SITE PLAN APPROVED
 OFFICE OF LIEP
 CITY OF ST. PAUL

By T. Bear
 File # 08-158044 Date 7/5/08
 Any alterations from this plan must be approved by the Zoning Administrator.

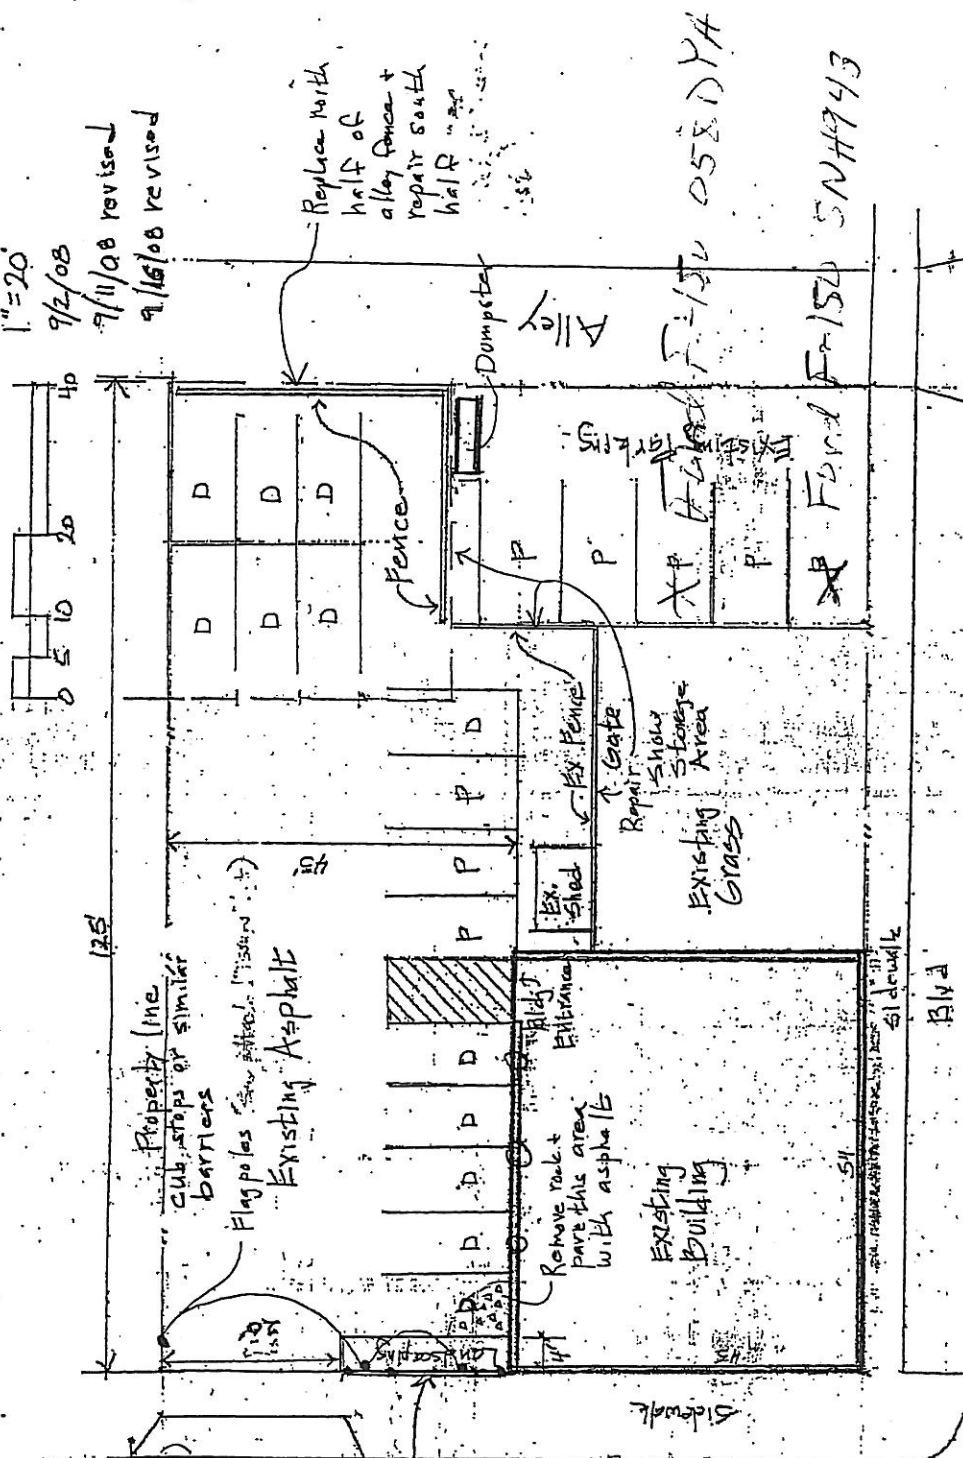
Existing street sign probably needs to be moved for new driveway

New Driveway permit and PWT + MNDOT required

40" high ornamental metal fence with hedge planted behind
 Alpine Curator or equivalent at 18' on E
